SERVICE BULLETIN

SB-041316 REV A

DATE ISSUED: 4/13/2016
DATE EFFECTIVE: 4/13/2016
SUPERSEDES NOTICE: None
SUBJECT: TEMPORARY V_{NE} SPEED LIMITATION
AIRCRAFT AFFECTED: **MODEL:** A5
S/N: 00001, 00003, 00004
REQUIRED ACTION: ADD PLACARD TO INSTRUMENT PANEL AND UPDATE POH
TIME OF COMPLIANCE: PRIOR TO NEXT FLIGHT UNTIL ELEVATOR IS BALANCED

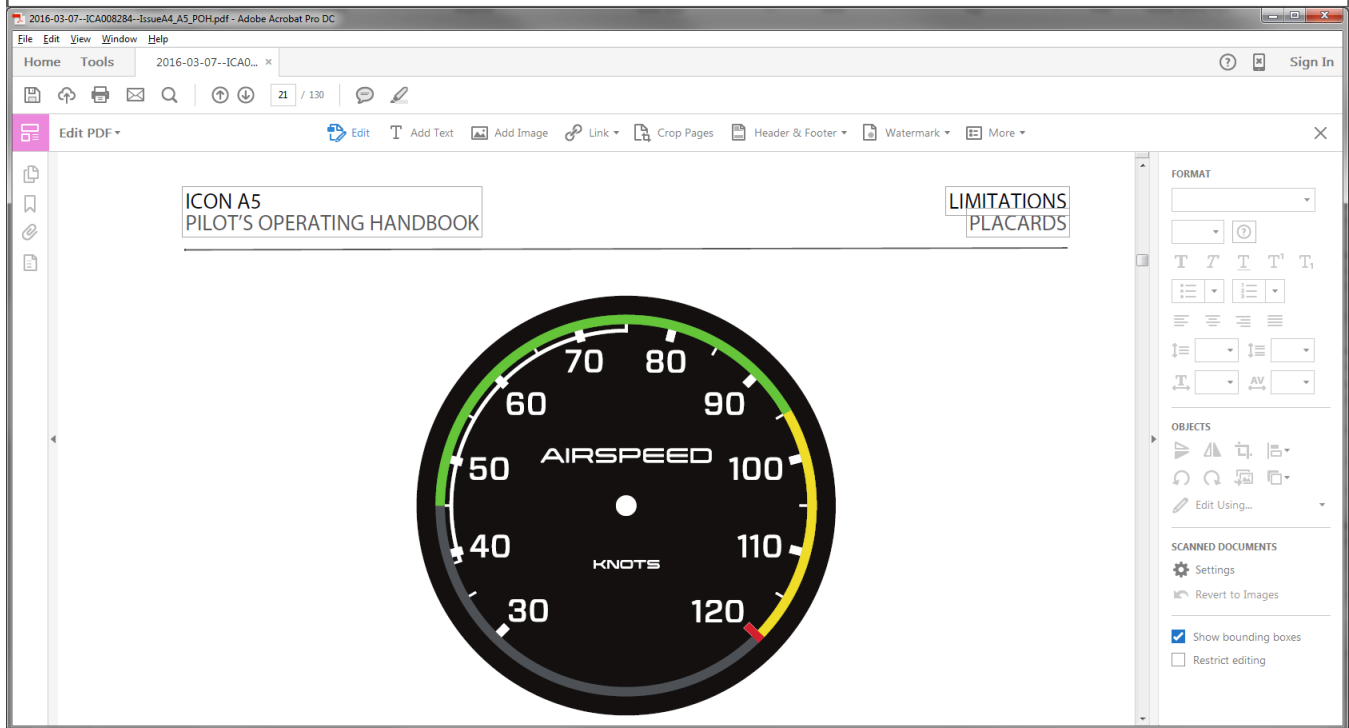
- 1) Place a red band at the 100 knot mark on the face of the airspeed indicator (Reference Fig. 1)
- 2) Cut out and tape the included speed limitation placard into the Pilot's Operating Handbook (POH).
